COUNTAX

SERVICE BULLETIN

14-T3-27

MK3 Scarifier, 300 Litre PGC & Spreader
MK4 B Series B60-4TRAC, B250-4TRAC / C Series C50, C60, C80 / F Series F60-4TRAC, F250-4TRAC / T Series T50, T60 & T80.
Pre 2014 model accessories require an additional cable plug n order to function with MK4 tractors.

Problem

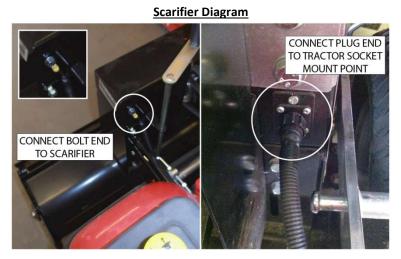
The 2014 MK4 tractor is designed with added safety features not found on earlier models. 2014 rear mounted, belt driven accessories will not function without a safety cut out switch that plugs into a rear tractor port. **Accessories made before 2014** lack the necessary cut out switch and will require a cable plug to function with the new tractor.

- 1. Fit the loop end to the accessory (PGC / Scarifier / Spreader).
- 2. Secure the cable plug using the unused bolt hole and kit fixings (see diagrams below).
- 3. Link the plug to the tractor by connecting the plug end with the tractor socket mount (see diagram below).
